Access Compliance Report

Public Rights-of-Way

(Curb Ramps)

Intersection ID: 49277	Main Street: REUNION_ST	Cross Street: HOMECOMING_WY	Location: NW
ADA ID: A91D7743D8F6	Ramp Type: Perp	Initial Pass/Fail: Fail	Overall Compliance: No
Severity Score: 13.75			
Codes/Mitigation Info/Possible Solution		Field Measurements/Component Compliance

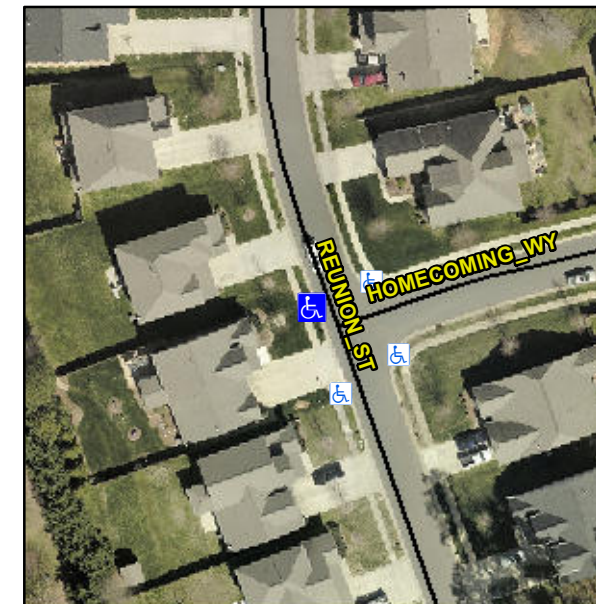
Not Found, R304.2.2, R304.5.3

Compliance	Description	Data	Compliance	Description	Data
N/A	Ramp Length (in)	49.0	No	Ramp Slope (%)	9.7
Yes	Ramp Width (in)	48.0	No	Ramp XSlope (%)	3.2
N/A	Flare Type LT	N/A	N/A	Flare Type RT	N/A
N/A	Flare Slope LT (%)	N/A	N/A	Flare Slope RT (%)	N/A
N/A	Flare Traversable LT?	N/A	N/A	Flare Traversable RT?	N/A
N/A	Landing Length (in)	N/A	N/A	DWS Provided?	N/A
N/A	Landing Width (in)	N/A	N/A	DWS Contrast?	N/A
N/A	Landing Slope (%)	N/A	N/A	DWS Length (in)	N/A
N/A	Landing X Slope (%)	N/A	N/A	DWS Full Width?	N/A
N/A	Landing Curb? (Y/N)	N/A	N/A	DWS Offset (in)	N/A
N/A	Shared Landing?	N/A			
N/A	Gutter Ponding?	N/A	N/A	Gutter Slope (%)	N/A
N/A	Gutter Lip Ht (in)	N/A	N/A	Gutter X Slope (%)	N/A
N/A	Painted X Walk1?	No	N/A	Painted X Walk2?	N/A
	X Walk 1 Direction	To E		X Walk 2 Direction	N/A
N/A	X Walk 1 Width (in)	N/A	N/A	X Walk 2 Width (in)	N/A
	X Walk 1 Slope (%)	3.5		X Walk 2 Slope (%)	N/A
	X Walk 1 X Slope (%)	3.0		X Walk 2 X Slope (%)	N/A

Remove & Replace Entire Ramp.
